1000BASE-T PHY Control State Diagram Modifications

**Niall Fitzgerald, Adam Healey,
Brian Murray, Jacobo Riesco**
LSI Corporation

Presented by Adam Healey
IEEE P802.3az Task Force Meeting
New Orleans, LA
January 2009

Approaches to comments #98 and #101 – 1

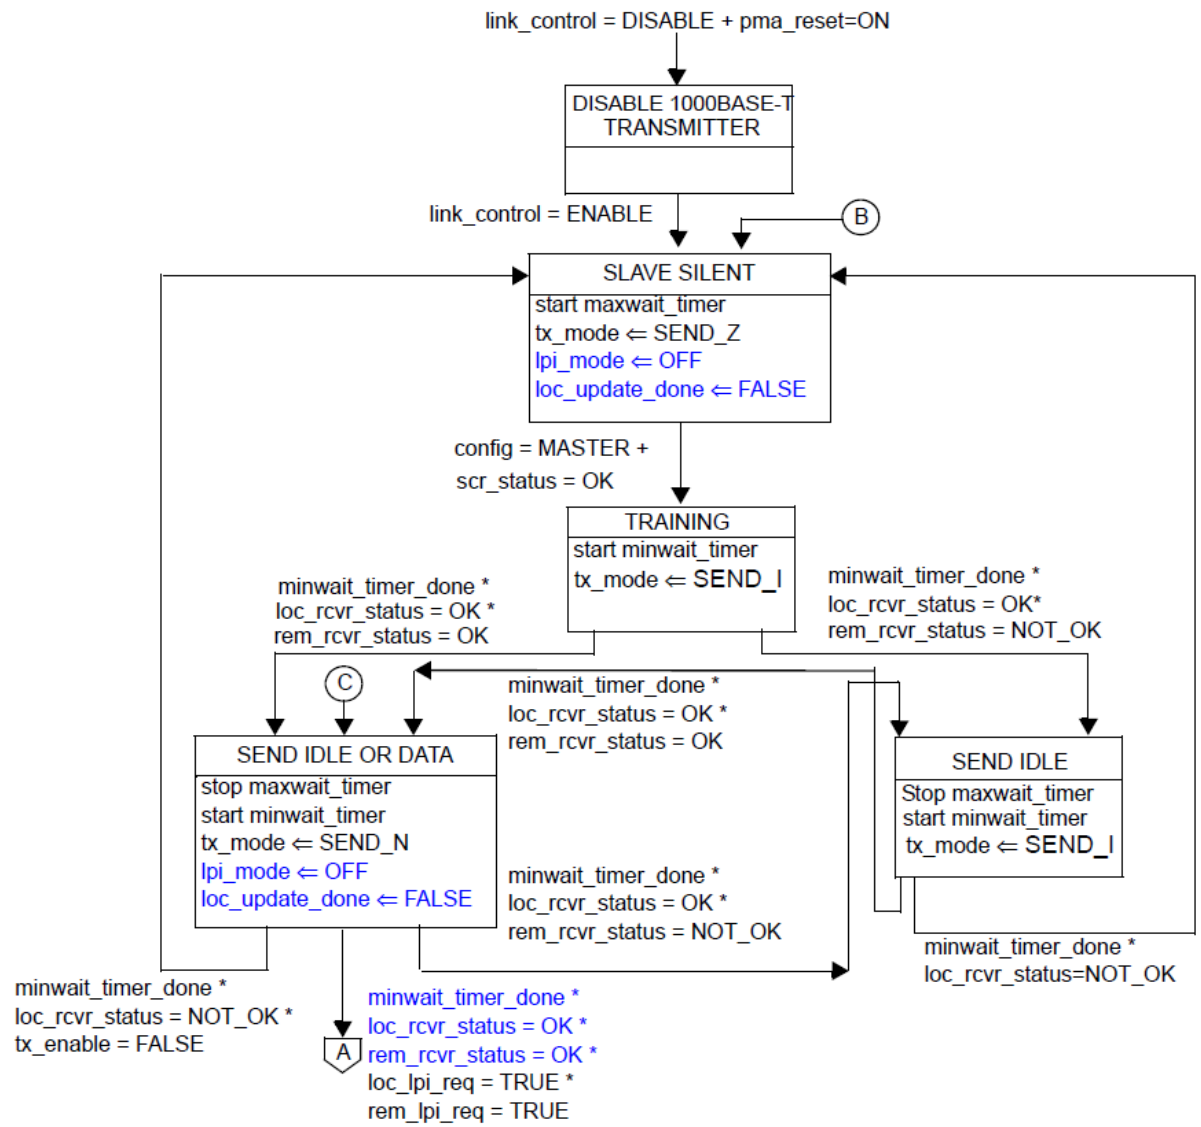
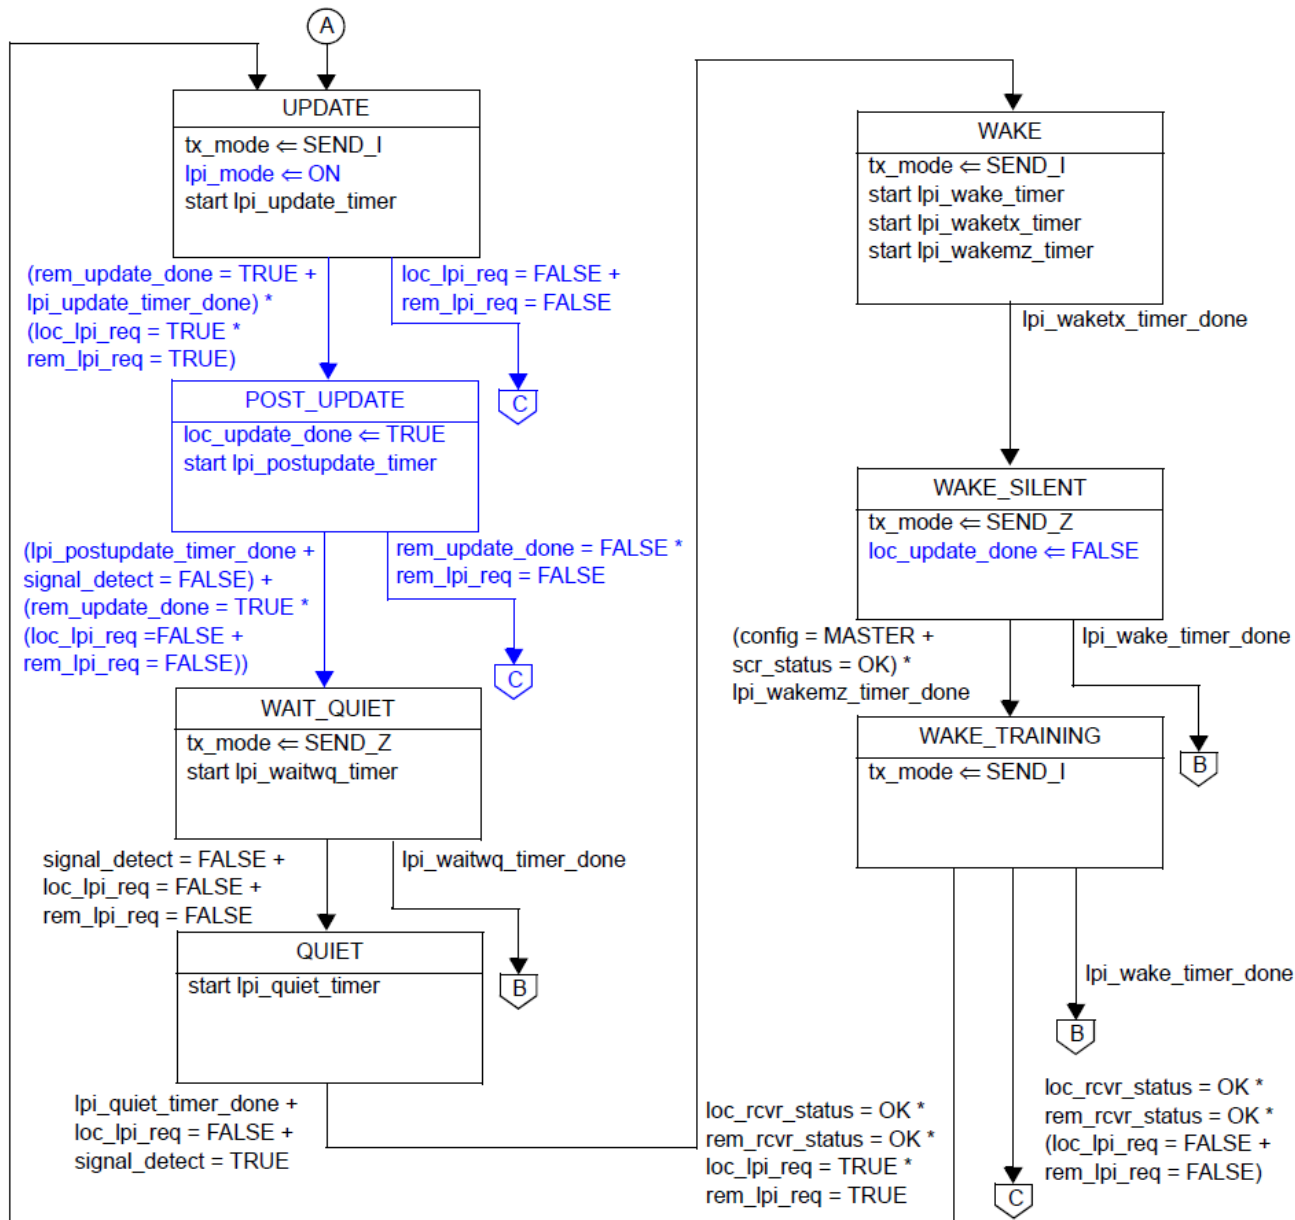
- PHY Control state diagram allows a transition from UPDATE to WAKE to be forced at any time by the assertion of `loc_lpi_req = FALSE`
 - This results in continued transmission for `lpi_waketx_timer` followed by a period of silence (`tx_mode = SEND_Z`) no less than `lpi_wakemz_timer`

- This permits pathological timing scenarios where `LP_IDLE` is asserted at the GMII such that the PHYs transitions to the UPDATE state and then `LP_IDLE` is de-asserted forcing the link partner to abort update of timing and adaptive filter coefficients

- Repetitions of this timing cycle can starve the PHY of essential updates and degrade link performance
 - This issue could also be addressed by enforcing a minimum period that the "LPI client" must assert `LP_IDLE`

- Define the minimum time the “LPI client” must assert LP_IDLE
 - To ensure that both the local device and link partner both enjoy a period of uninterrupted transmission of a least lpi_update_timer (T_u)
 - No less than $2T_u(\text{min.}) + T_w(\text{min.})$, where T_w corresponds to lpi_wake_timer
 - No less than 376 microseconds
 - This translates directly to the size of the buffer that must be maintained by the transmitter
- Define the minimum time the client must wait between de-asserting LP_IDLE and asserting LP_IDLE again
 - Again, to ensure a period lpi_update_timer of uninterrupted transmission
 - No less than the minimum value of T_u (180 microseconds)

Highlights

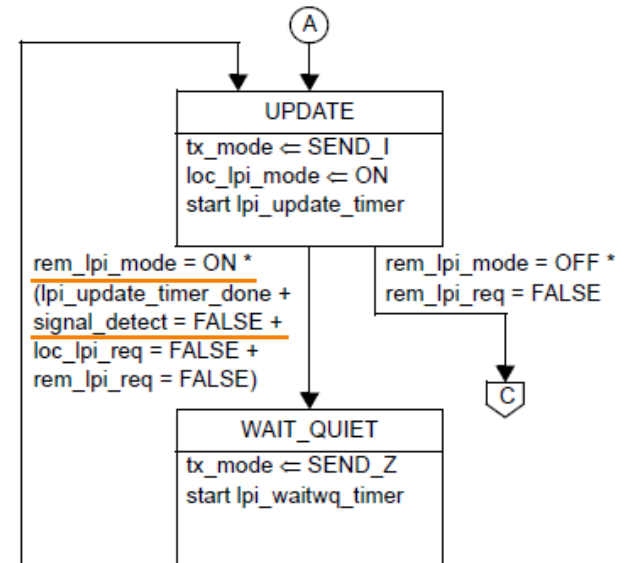
- Introduce new POST_UPDATE state, succeeding the UPDATE state, controlling transitions into WAIT_QUIET or SEND IDLE OR DATA
- Restore lpi_mode to its Draft 1.0 definition
- Introduce new variable loc_update_done
 - Indicates completion of timing and adaptive filter coefficient updates
 - Assigned a value of FALSE prior to entering the UPDATE state
 - Assigned a value of TRUE in the POST_UPDATE state
 - Communicated to the link partner and received as rem_update_done
 - Use the same encoding rules adopted for loc_lpi_mode (possibly modified by comment #100)
- Remove the transition from WAKE_TRAINING to WAKE_SILENT
 - It was added to combat a fall-through case in the Draft 1.0 state diagram which no longer exists in Draft 1.1
- Remove lpi_waitwt_timer
 - It was added to combat a fall-through case in the Draft 1.0 state diagram which no longer exists in Draft 1.1

- A direct transition is provided from UPDATE (or POST_UPDATE) to SEND IDLE OR DATA if the link partner has not yet completed filter coefficient updates (e.g. `rem_update_done = FALSE`)
 - Update of adaptive filter coefficients may continue uninterrupted
- When the remote PHY has signaled completion of update then the transition through to the wake sequence is possible
- Duration of `lpi_postupdate_timer` is required to be greater than one round-trip delay
 - Propose a range of 2.0 and 2.2 microseconds
- If `loc_lpi_req = FALSE` during POST_UPDATE, then the local device must wait for `rem_update_done = TRUE` before proceeding to WAKE
 - This will not add time to the overall wake time budget

Comment #12: Stuck in update

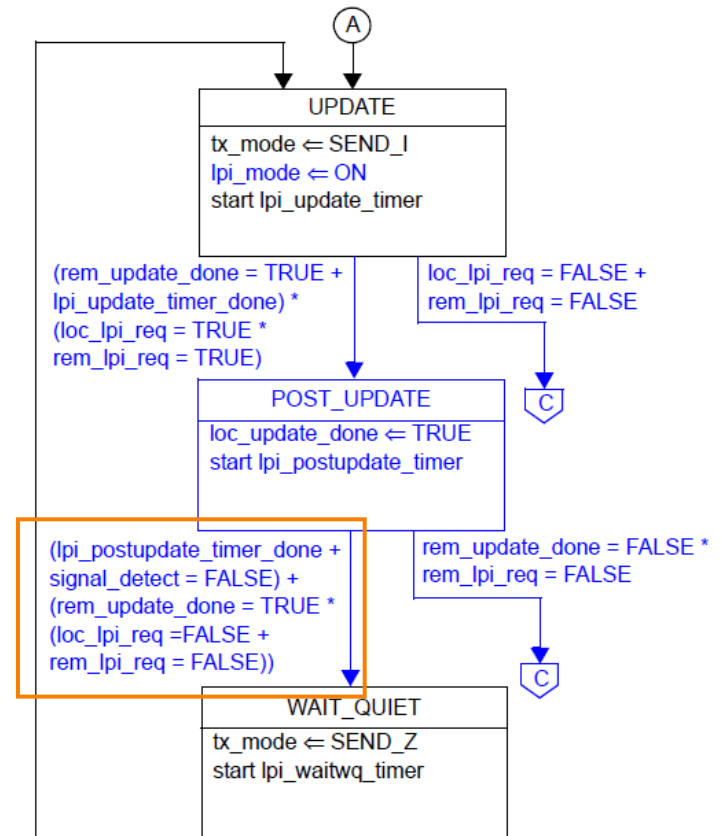
- Transition condition from UPDATE to WAIT_QUIET includes the term $\text{rem_lpi_mode} = \text{ON} * \text{signal_detect} = \text{FALSE}$
- How can rem_lpi_mode be detected when there is no signal present?
 - What value of rem_lpi_mode should be assumed?

- Condition could be modified to remove this ambiguity
- $\text{signal_detect} = \text{FALSE} + \text{lpi_update_timer_done} + \text{rem_lpi_mode} = \text{ON} * (\text{loc_lpi_req} = \text{FALSE} + \text{rem_lpi_req} = \text{FALSE})$
- Correction eliminates corner cases pointed out in Comment #12
- Correction already presented in the proposed state diagram
 - POST_UPDATE to WAIT_QUIET

Comment #102: Summary of proposal

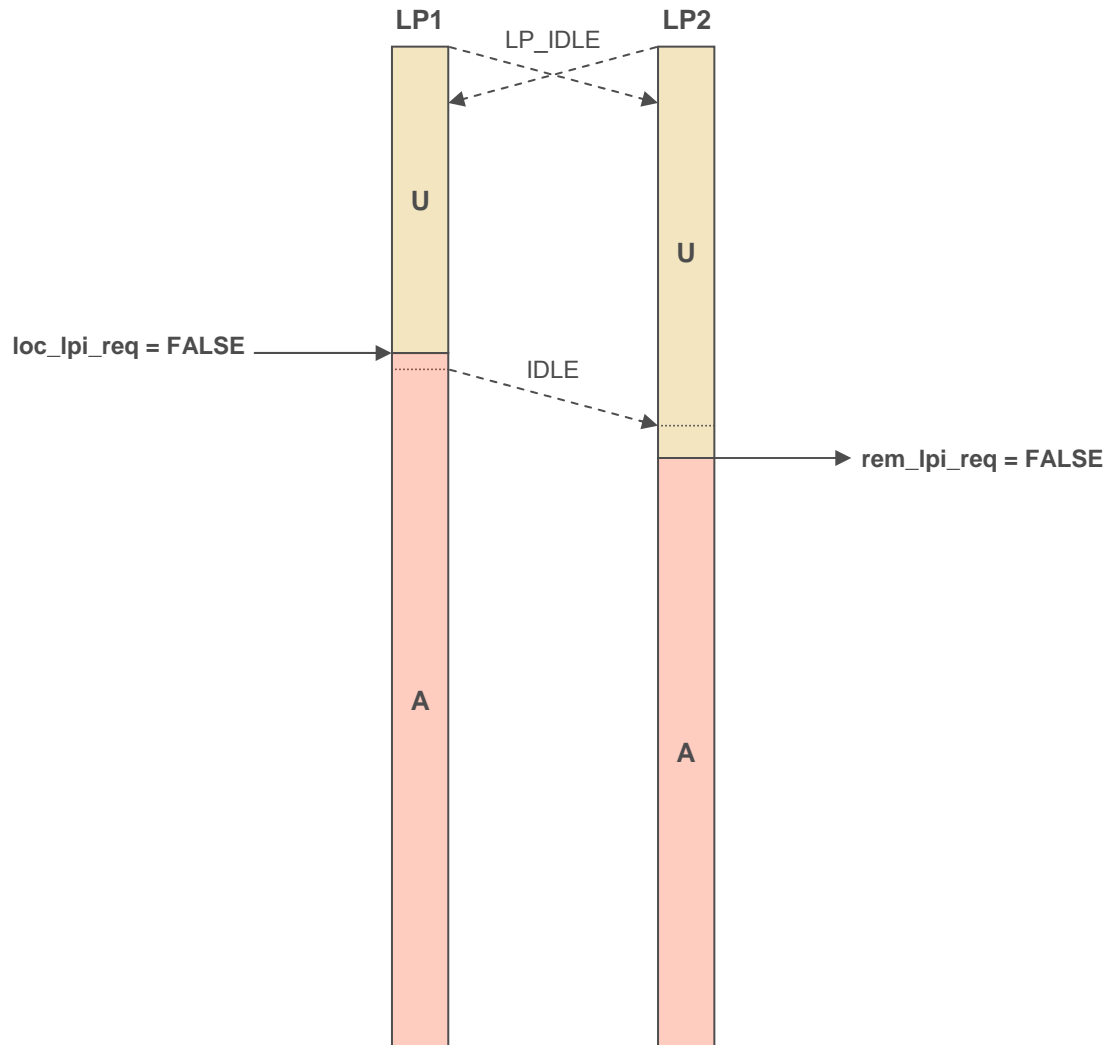
- Failure to achieve both `loc_rcvr_status = OK` and `rem_rcvr_status = OK` prior to `lpi_wake_timer_done` causes PHY Control to transition to the SLAVE SILENT state and initiate re-training
 - This will correspond to an interruption of service spanning hundreds of milliseconds
- Consequences are considerably more severe in all cases when re-training is enforced
- Even though such event should be rare, the same could be said of frequency of a packet error during normal operation
 - During normal operation, the link is not restarted for every packet error

- Use `lpi_wake_timer` to monitor the health of the link
 - Define that `lpi_wake_timer_done` causes a new counter, “1000BASE-T wake error,” to be incremented
 - Counter is represented in the Clause 45 management register space and is cleared on read
 - System management reads the counter to understand if the link is failing to recover from low-power mode within the allotted time and takes corrective actions as necessary
- Define a new timer, `lpi_link_fail_timer`
 - Functionally replaces `lpi_wake_timer` in the PHY Control state diagram, e.g. expiration triggers re-training
 - Started in the WAKE state
 - Propose timer value to be 90 to 110 microseconds
- Add action “Stop `lpi_wake_timer`” to SEND IDLE OR DATA to prevent `lpi_wake_timer_done` from being satisfied after completion of wake
